Name	Signature			Date
Application made by:	SCSJV				19/07/2023
Location (Sector/Site Name):	Adelaide Road Vent Shaft, Adelaide Road				
LAA/LAP/Site Reference	LAP02475 and parcel outside Act Limits				
Work Package number:					
Date of Tree Panel:	28 July 2023				
Site Description:	East end of Adelaide Road Vent Shaft site				
Reason for clearance:	<p>The removal is required to allow for the installation of a walkway and LV cable from Adelaide Road to the DNO box at the base of the embankment.</p> <p>Dead trees on site pose a safety risk to the workforce and require removal.</p>

Site Sketch/ Diagram / Photos attached

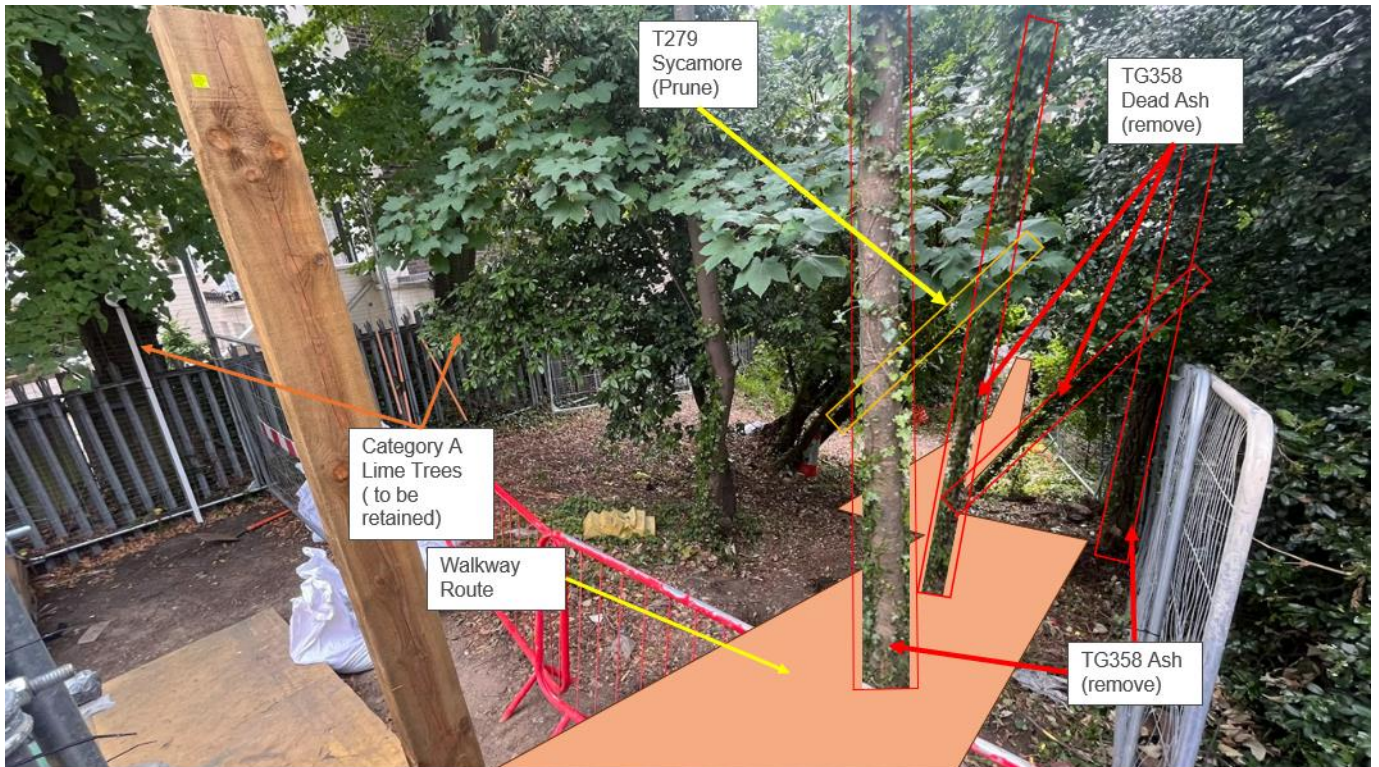
Drawing Reference No:					
	Yes	No	N/A	Comments	
Has the Stage 1 Survey been completed and logged on the Register	X				
	Yes	No	N/A	Comments	
Has the Stage 2 Survey been completed with retention and protection measures logged on the Register	X				
Have all practicable means to negate need for works to tree been investigated? Please provide details	<ol style="list-style-type: none"> 1. The removal of 2 category C trees, 2 dead trees and pruning of 1 limb helps to mitigate any damage to the existing category A trees which are outside of the site boundary. 2. Dead trees on site pose a safety risk to workforce

Proposal not endorsed/endorsed	<p>Endorsed: removal of F307 and reduction in height of F304 and F312 to a safe level.</p> <p>Not endorsed: T013, T023 and T017 (the trees on Network Rail Land)</p>
Conditions	<p>Regarding the trees not endorsed by tree panel, before presenting this again SCS are to provide evidence of the contractual relationship with Network Rail, including who is paying for the works, what powers the works are being completed under and who owns the land that the proposed walkway would be constructed on.</p>
